Subject: Re: [Application No. A/NE-STK/32] – Comments from the Leisure and Cultural Services Department

Proposed Temporary Holiday Camp, Place of Recreation, Sports or
Culture (Hobby Farm), Field Study/Education/Visitor Centre, and
Public Vehicle Park (excluding Container Vehicle) for a period of 3 years
in “Village Type Development”, “Recreation (1)”, and the areas are
shown as ‘Road’ of various Lots in D.D 41 and the adjoining
Government Land, Sha Tau Kok, New Territories.

Further Comments from the New Territories North Tree Team LCSD:

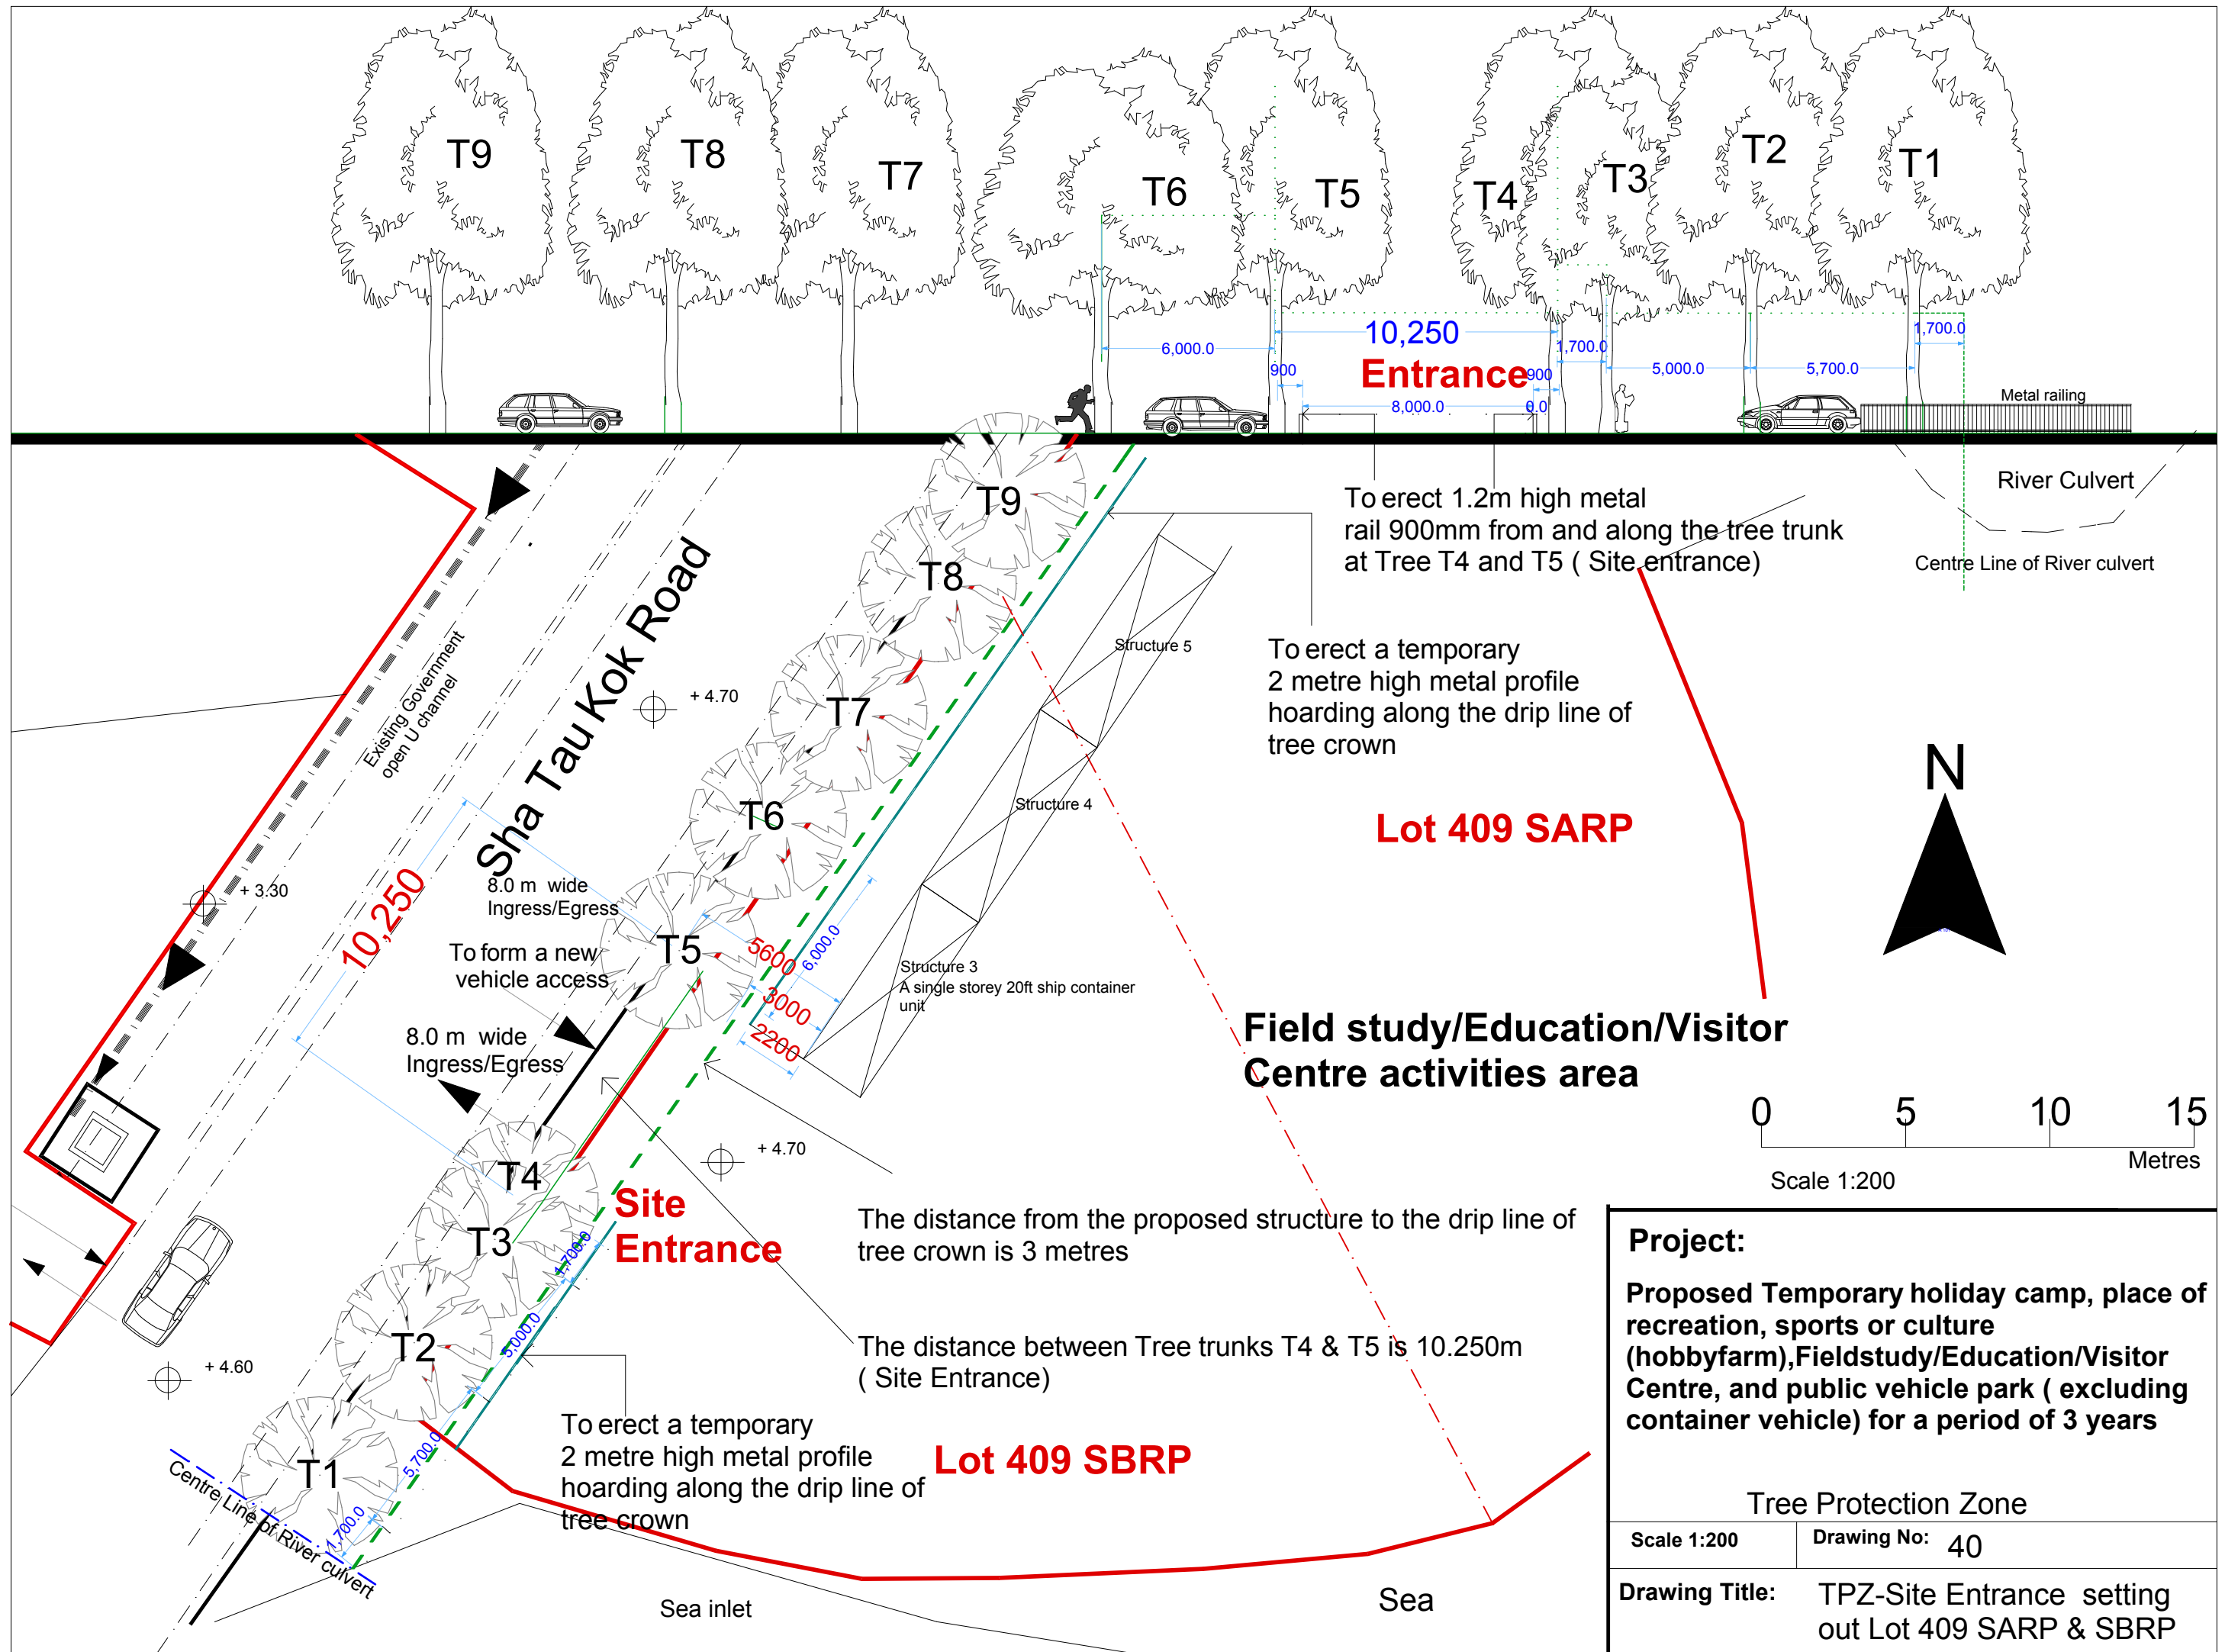
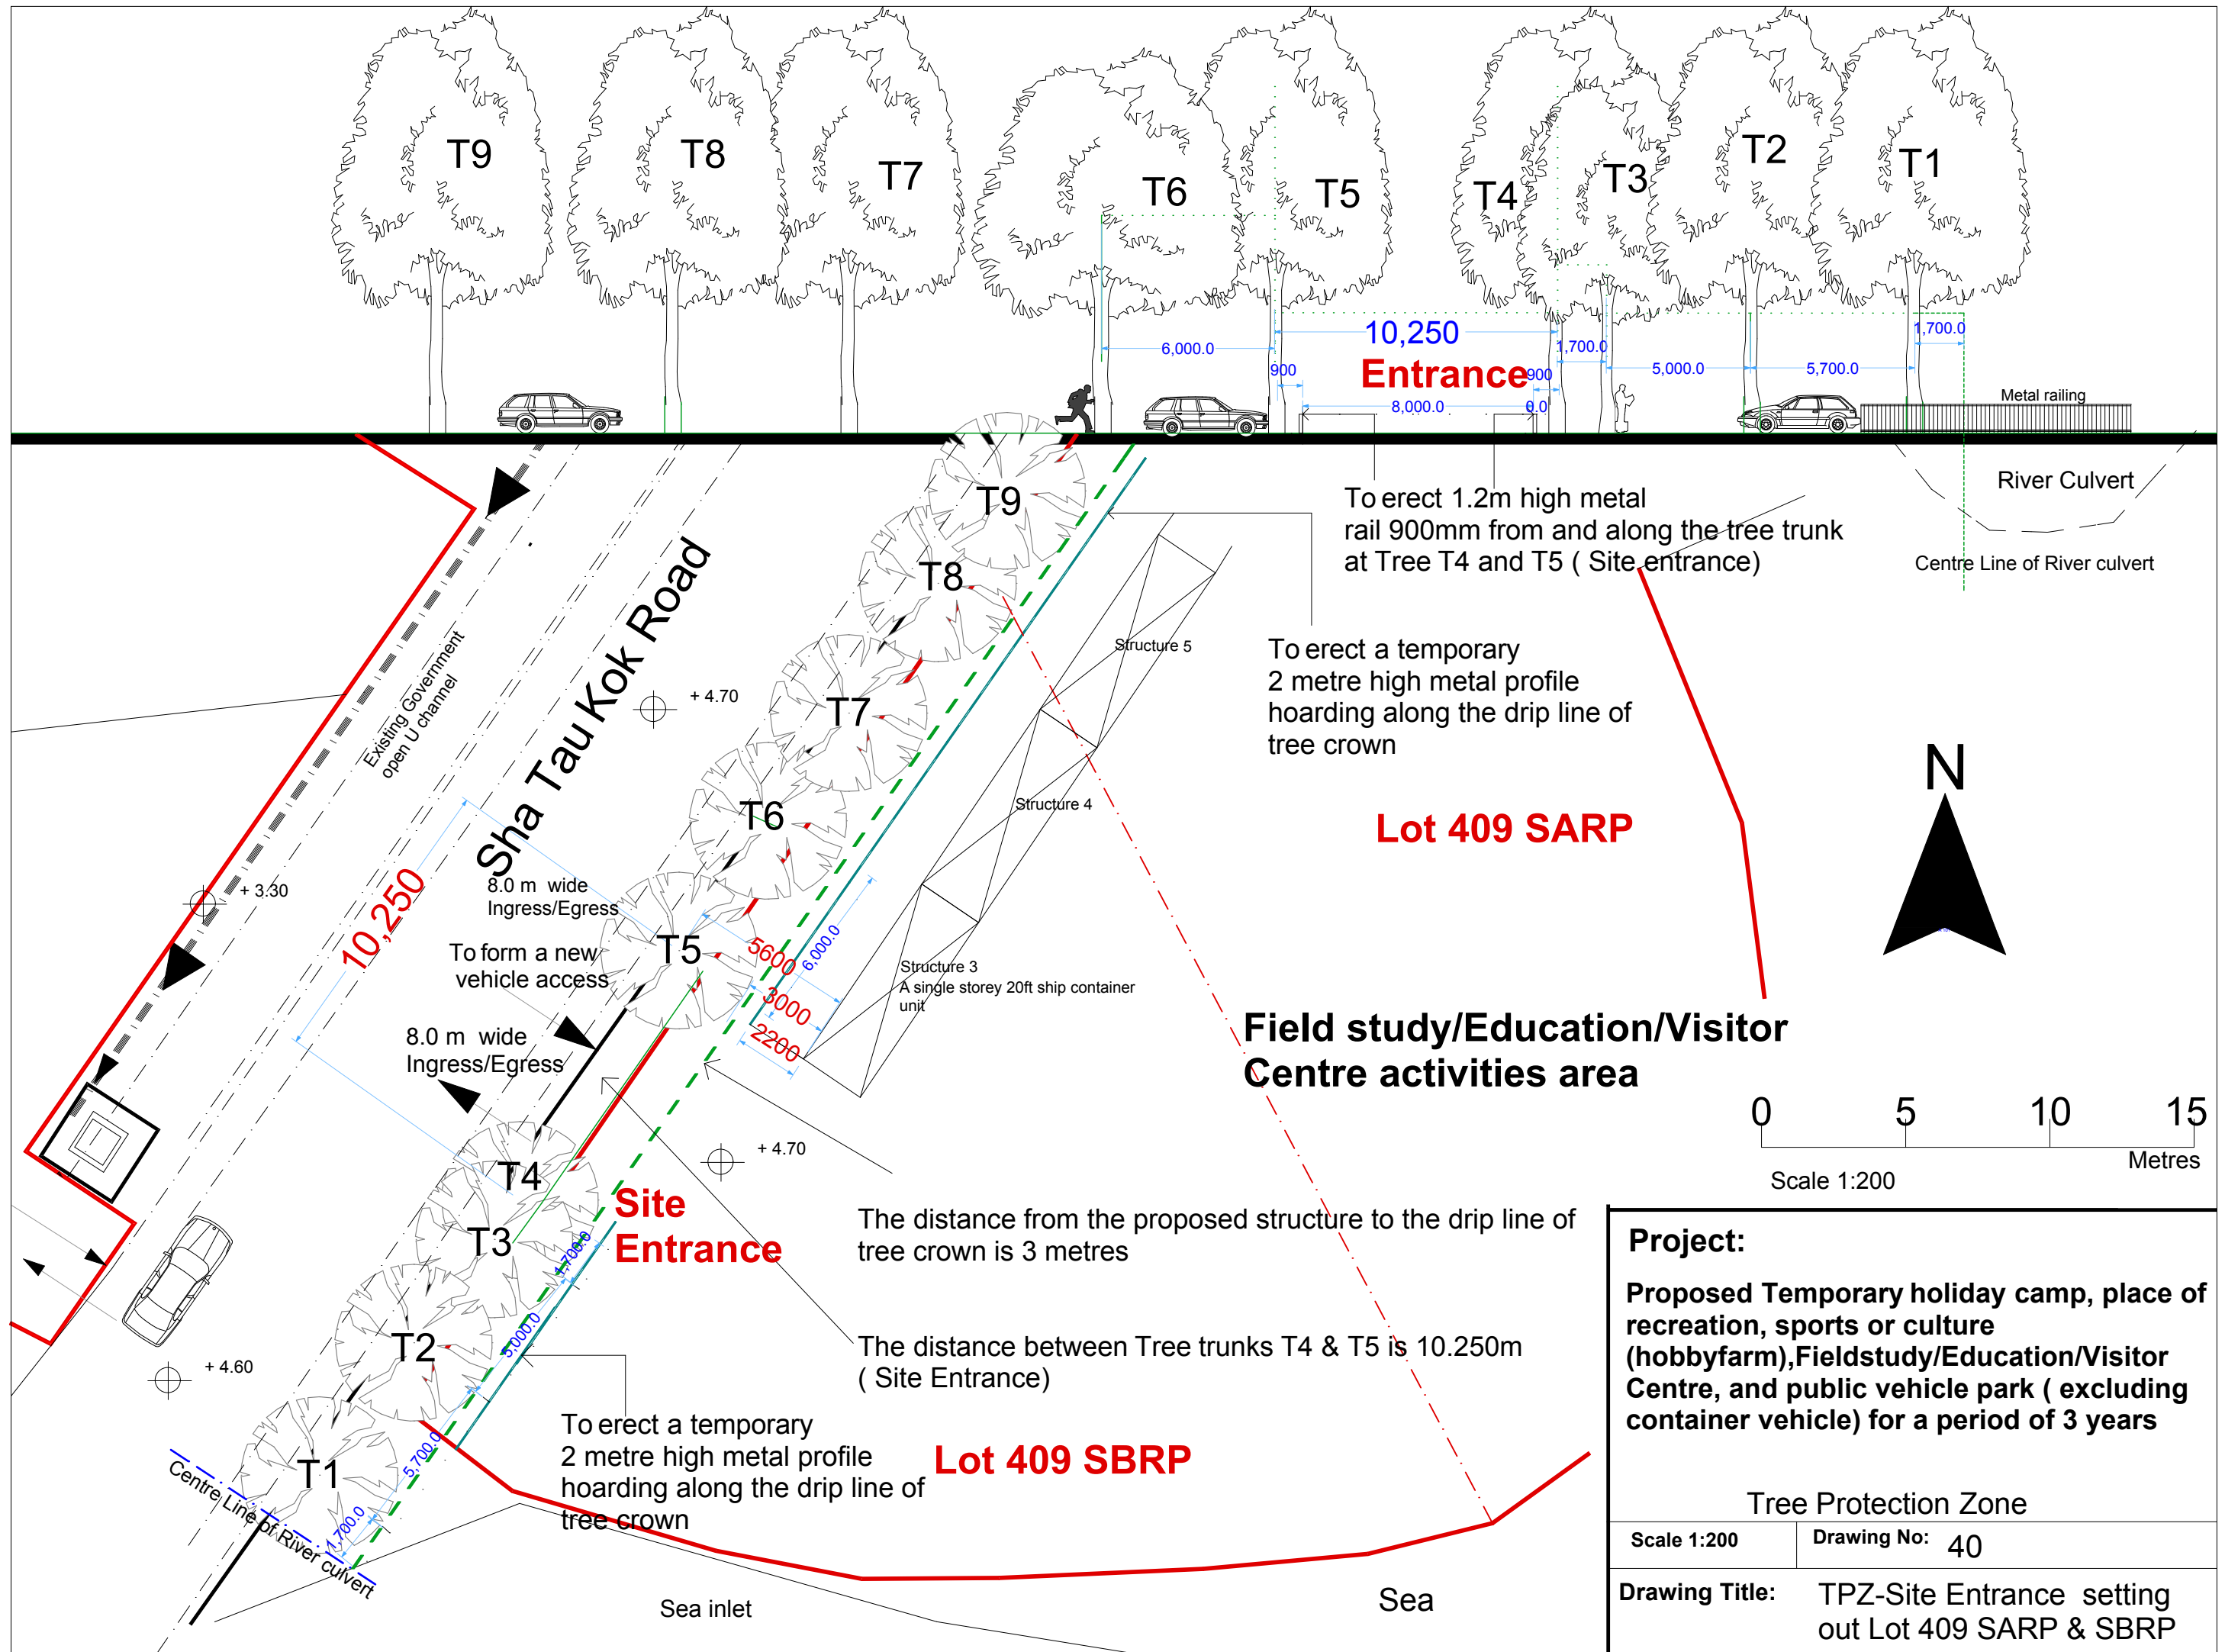
The applicant should revise the proposed vehicular access points to avoid affecting nearby trees. Should any tree under LCSD maintenance be inevitably affected by the captioned application, the applicant should act in accordance with the prevailing Technical Circular DEVB TC(W) No. 4/2020 - Tree Preservation (Available at: <https://www.greening.gov.hk/en/resource-centre/technical-circulars-practice-notes-and-guidelines/index.html>) and relevant guidelines stipulated by the Development Bureau and other departments.

To protect and preserve trees and the suburban area of the Application Site during the construction phase, a temporary, two meter high metal profile, hoarding along the drip line of the tree crown will be erected. In addition, a 1.2 meter high metal rail, will be erected on both sides of the site entrance. When the Application Site is in operation, the temporary hoarding will be upgraded to a more durable and sustainable uPVC Composite Fencing.
(Please refer to the Tree Protection Zone – Site Entrance Setting Out drawing submitted herewith).
